| Subject: HARD SHIFTING/SHIFT LEVER VIBRATION | Bulletin No: 05-001/15 |
| | Last Issued: 11/30/2015 |

- This bulletin supersedes the previous bulletins 05-001/15 issued on 11/11/15, 05-008/14 issued on 07/14/14 and 11/26/14 and 05-001/15 issued on 01/05/15. The PART(S) INFORMATION has been revised.
- Changes are noted below in Red beside the change bar.

Location of Transmission Related Parts

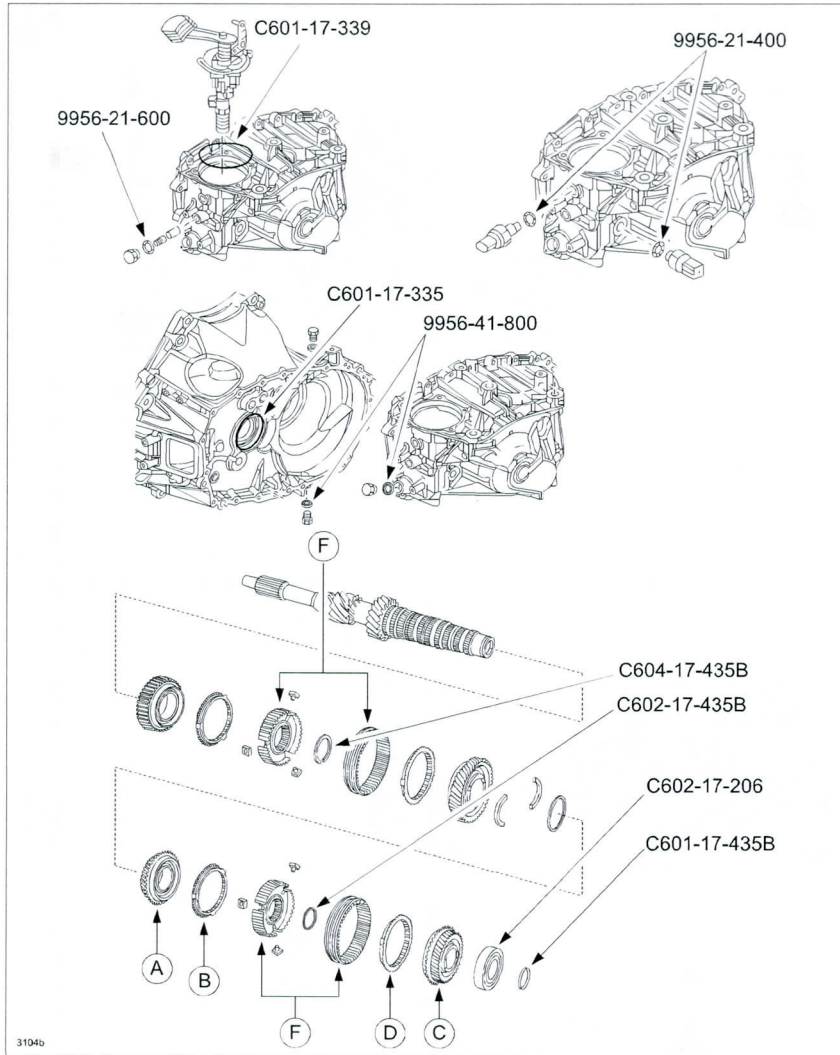
- Sometimes the shifter may jump out of 3rd gear over a road bump when accelerating after deceleration at 25-40 mph (40-65 km/h)
- Hard to shift into 3rd, 4th, 5th, and/or 6th gear
- Shift lever vibrates when driving in 3rd or 4th gear

This is caused by inappropriate transmission internal parts.

| Modification | Mass-Production Change | | Subject Concern |
|--------------|---|-------------------|---|
| A | 3-4 Clutch Hub | Surface treatment | Jumping out of gear |
| B | 3-4 Clutch Hub 5-6 Clutch Hub | Shape | Hard shifting into 3rd, 4th, 5th and/or 6th gear |
| C | 3rd and 4th Gears | Tolerance | Shift lever vibration |
| D | 3rd and 4th Gears 3rd and 4th Synchronizer Rings | Shape | Hard shifting into 3rd and/or 4th gear (additional improvement) |

| VINs | Symptom | | | |
|--|---|------------------------------------|---|--|
| VINs before Modification A | Replace: 1) 3/4 Clutch Hub 2) 3rd Gear and Synch. Ring | Replace: 1) 5/6 Clutch Hub | Replace: 1) 3/4 Clutch Hub 2) 3rd Gear and Synch. Ring 3) 4th Gear and Synch. Ring | Replace: 1) 3rd Gear and Synch. Ring 2) 4th Gear and Synch. Ring |
| VINs between Modification B and C | | | Replace: 1) 3rd Gear and Synch. Ring 2) 4th Gear and Synch. Ring | |

- A: 3rd Gear
- B: 3rd Synchronizer Ring
- C: 3/4 Clutch Hub Assembly
- D: 4th Synchronizer Ring
- E: 4th Gear
- F: 5/6 Clutch Hub Assembly
